U.S. Department of Energy
Office of River Protection

CONTRACT NO. DE-AC27-01RV14136 – TRANSMITTAL OF U.S. DEPARTMENT OF ENERGY (DOE), OFFICE OF RIVER PROTECTION (ORP) DESIGN OVERSIGHT REPORT ON HYDROGEN MITIGATION AND CONTROL SYSTEMS, D-04-DESIGN-007

Waste Treatment Plant Hydrogen Mitigation and Control Systems

D-04-DESIGN-007

Figure 3 - Yield Stress of Selected HLW Waste Feeds to be Received in the WTP Pretreatment Facility

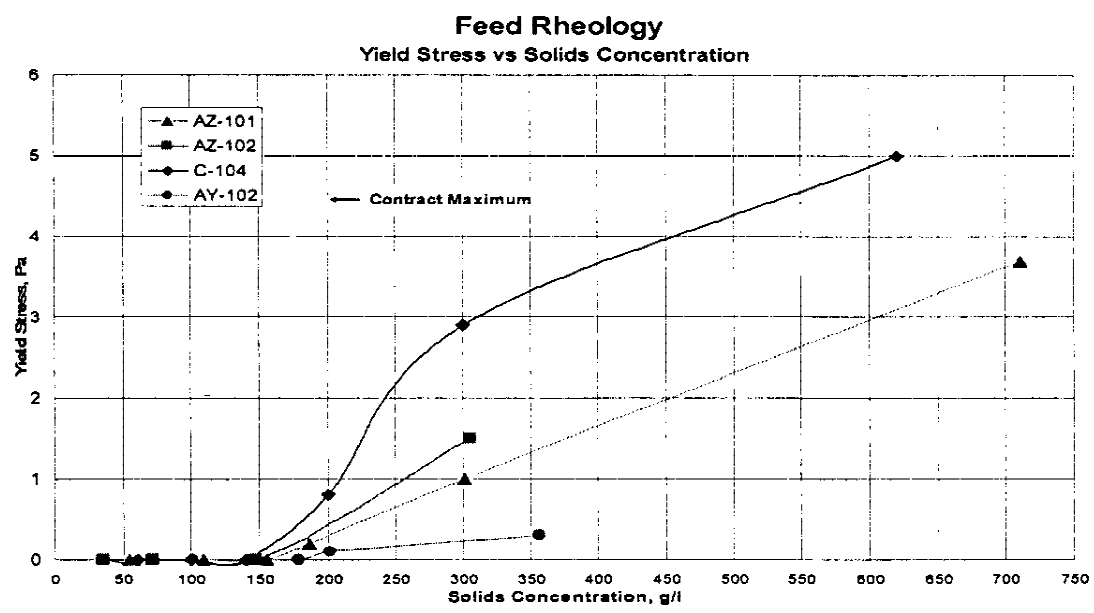
For select double shell tank wastes (AZ-101, AZ-102, C-104, and AY-102), BNI has determined, based on tank farm data, that only mild agitation is required to keep them in a Newtonian state when the “solids concentration” is below the contract maximum (200 g/liter). Above the contract maximum, the amount of agitation required to maintain solids in suspension increases as yield strength and apparent viscosity increase. However, the data indicate (see Figure 3) that even at very high solids concentrations (e.g., 600 g/l), the WTP feed slurries are only mildly non-Newtonian (i.e., yield strengths are below about 5 Pa).

The WTP Contractor has also compiled tank farm data which indicates that the WTP feed wastes appear to undergo 3 phases of settling during periods when they are not being mixed. The rate of solids settling is dependent on the particle size, particle density, and fluid density, but, in general, within the first five hours, about 90% of settling takes place. Hindered settling occurs from about 5 hours to 15 hours and compaction and the development of shear strength occurs at a very slow rate beyond 15 hours. Thus, significant compaction and the development of very high shear strength is likely to occur over timeframes of months rather than hours or days.
